## D/DRC Case

1401-1431 Assembly Street & 1011-1019 Washington Street

**Case # 4**

**NATURE OF REQUEST:** Request for Certificate of Design Approval for new construction of 15-story residential building

SOUTH ELEVATION - WASHINGTON ST.

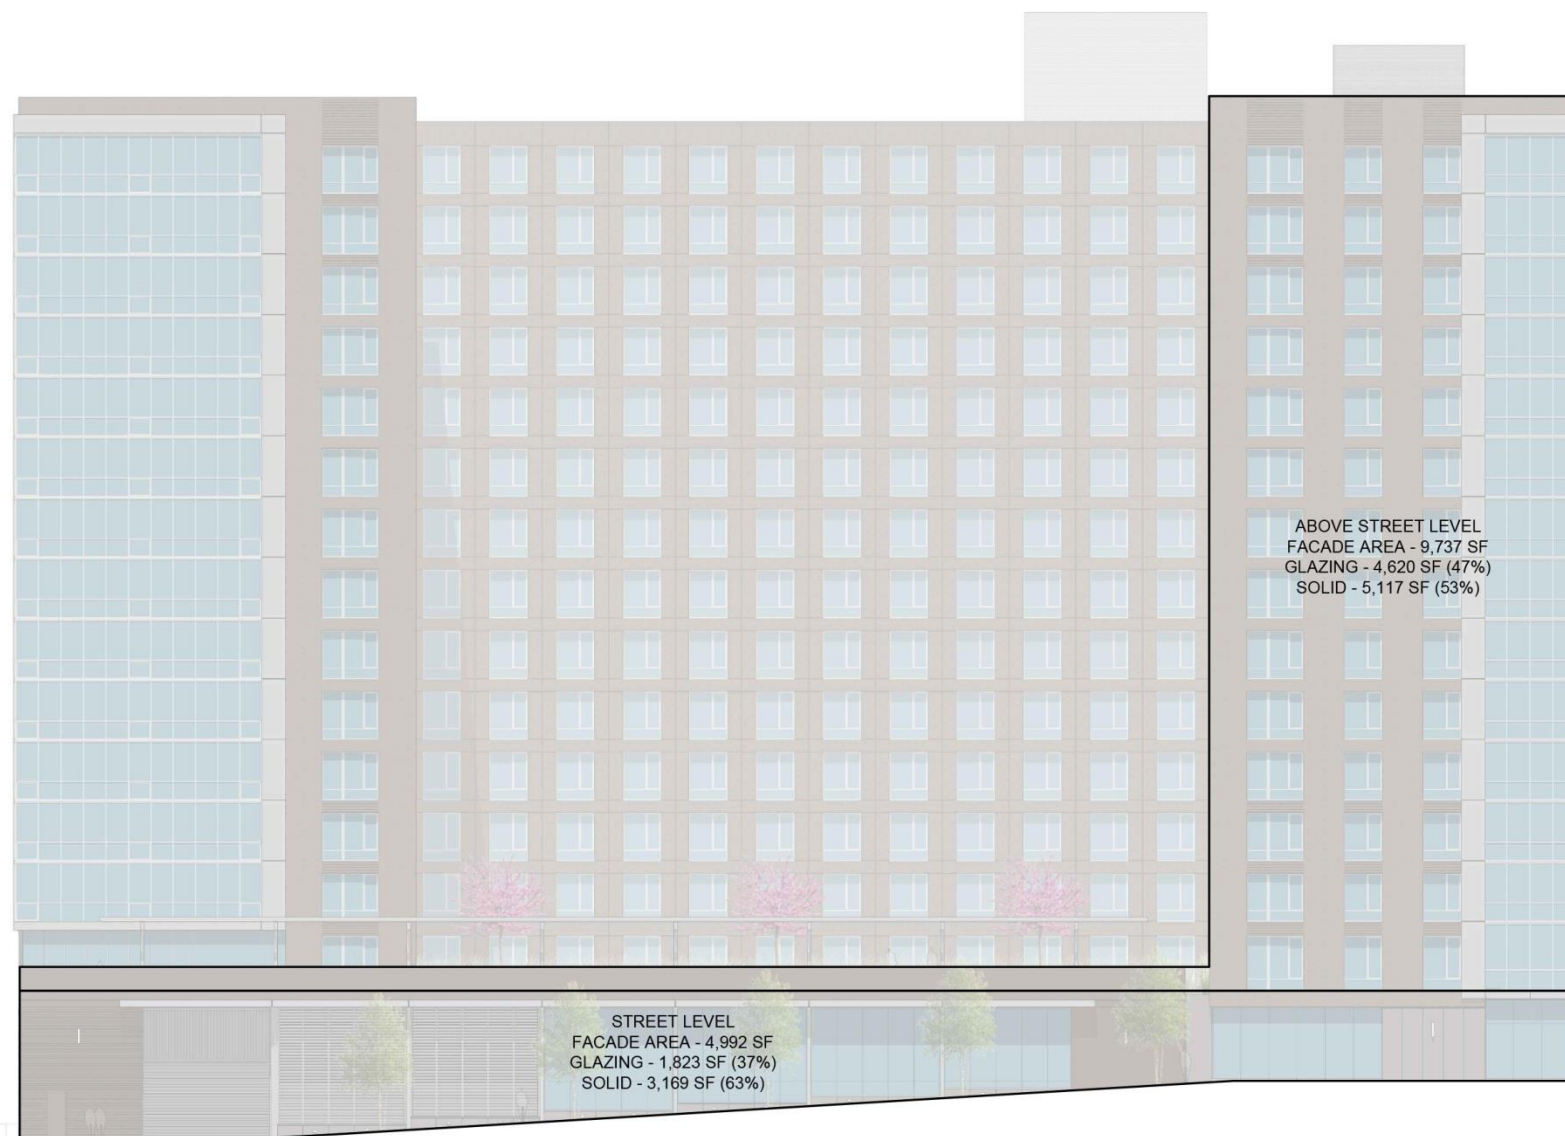
While pushing much of the 15-story massing back from the sidewalk does prevent the building from overwhelming the Washington Street section, there is a lack of transition in scale from the tower elements to the one-story volume along this streetscape. The massing could provide a more effective transition in scale if the Washington Street element were 2-4 stories, rather than one. The steel trellis and amenity deck

While the overall building is 15-stories, the one-story element along Washington Street is not in scale with the remainder of the building. Having a volume of at least 2-stories would hold the street edge better and be more consistent with this guideline.

The proportion of openings on the Assembly Street façade is 49% storefront/51% upper floors. The Washington Street façade has 37%/47%, respectively. The upper floors have a sufficient proportion of openings, however much more is needed on the ground-level frontage, particularly on Washington Street, where about a third of the storefront area is dedicated to garage/service area.

The street wall facades are a combination of glass curtain walls and solid pre-cast panels. These facades are somewhat monotonous and should be further articulated. Of greatest concern is the high-percentage of solid walls and mechanical screens fronting Washington Street.

While Washington Street may be considered the side street, it will act as a primary pedestrian corridor for residents and other pedestrians travelling east/west. The amount of non-programmed space along the Washington Street elevation is of significant concern for the success of the pedestrian environment.

The garage entry, electrical room, transformer, etc. located at the west end of the Washington Street ground floor accounts for 80 feet of frontage along this façade. The utility rooms should be located on the west or north side of the building, away from the street frontage.

The parking is primarily located interior to the block, with programmed space around it facing the street. Where the grade drops on Washington Street, however, there is a large portion of the elevation dedicated to service, utility rooms, and ventilation. These detract from the pedestrian experience and should be relocated.

- Reconfiguring the Washington Street elevation to include at least a 2-story massing along the entire street frontage
- Reconfiguring the first/ground level along Washington Street to include additional programmed space, as well as architectural features and details to enhance the pedestrian experience.
- Provide detailed information about recesses and projections of materials and massing
- Recess the amenity deck trellis so that it is not visible from the street
- Provide detailed information about the north façade that will be adjacent to the library plaza; roof-mounted utility equipment screening; and storefront glazing
- Provide detailed/dimensioned streetscape design, to include sidewalks, trees, lights, and any other site furnishings.

DTL @ WINDOW HEAD @ STUCCO  
3" = 1'-0"

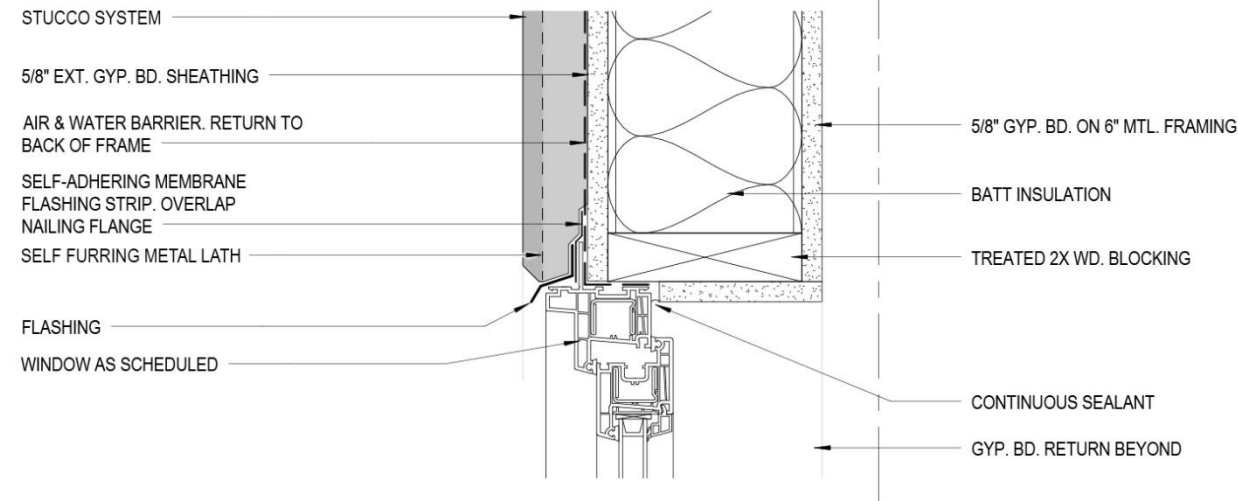
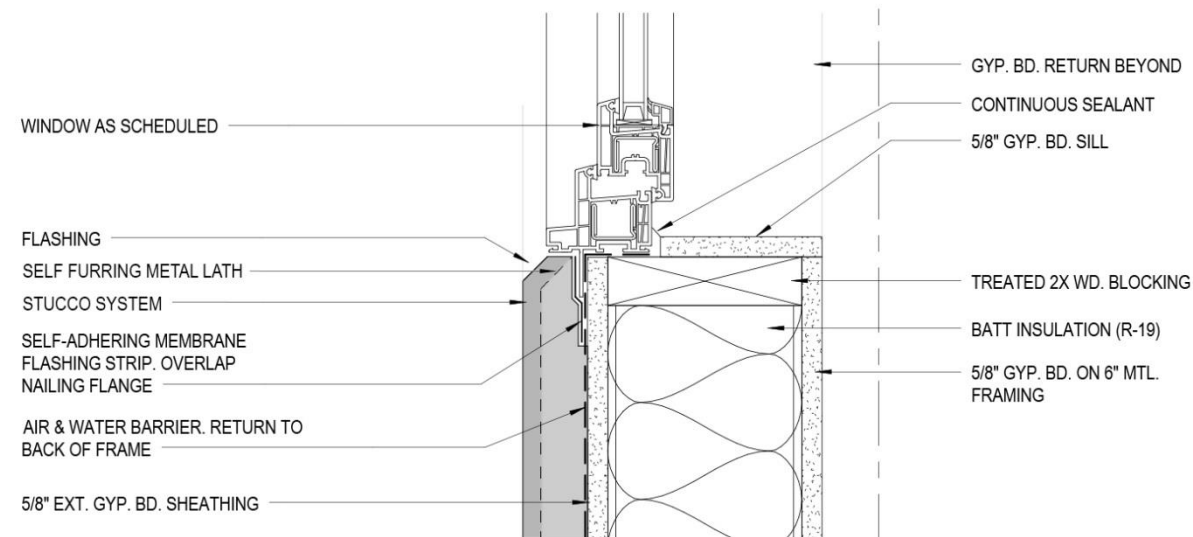
The stucco window section shows a 1 ½” depth, which is typical for this material. Section/elevations should be provided for the east and west elevations that face into the courtyard.

DTL @ WINDOW HEAD @ BRICK  
3" = 1'-0"

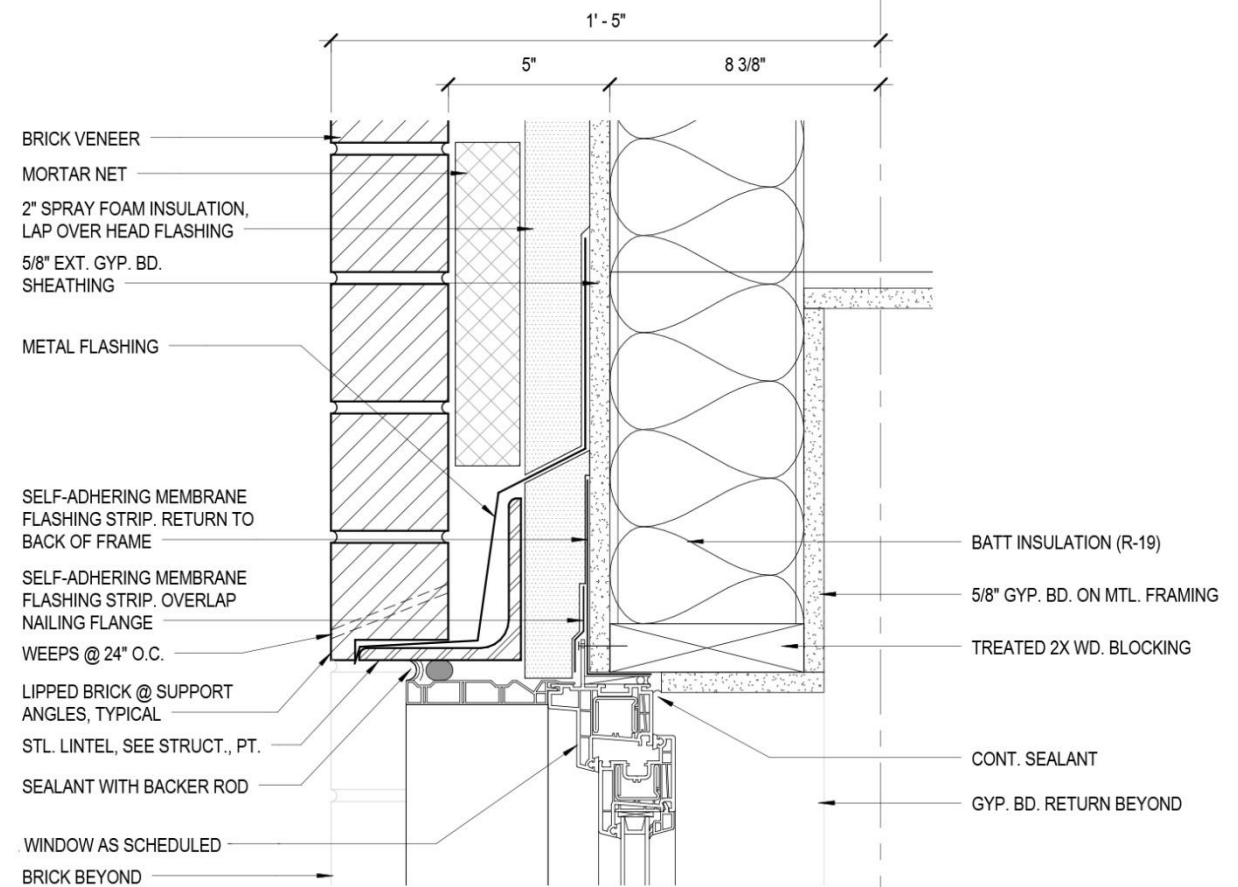
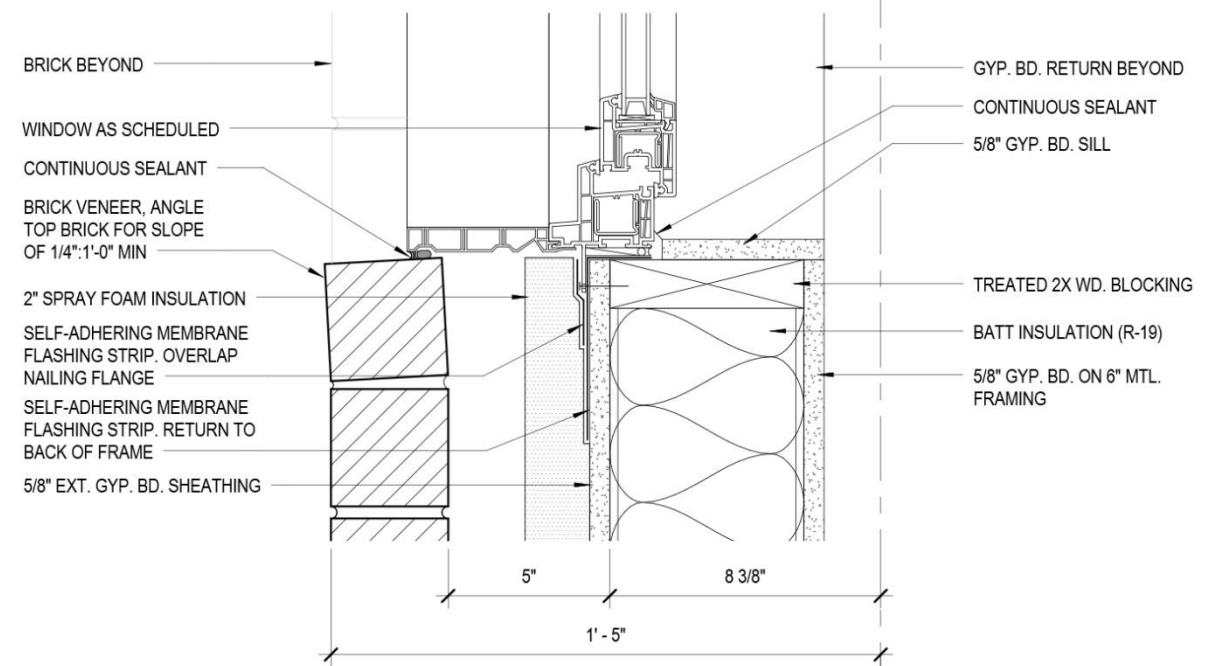
The key to articulating the massive upper façade and the regular pattern of windows is the depth of the window section. The applicant has provided detailed sections of the window configurations. The punched window sections in the brick show a 5” depth with the brick depth and the window frame trim. This is a good depth that should have a distinct shadow line. It is critical that this detail remain part of the design throughout value engineering, and construction documentation.
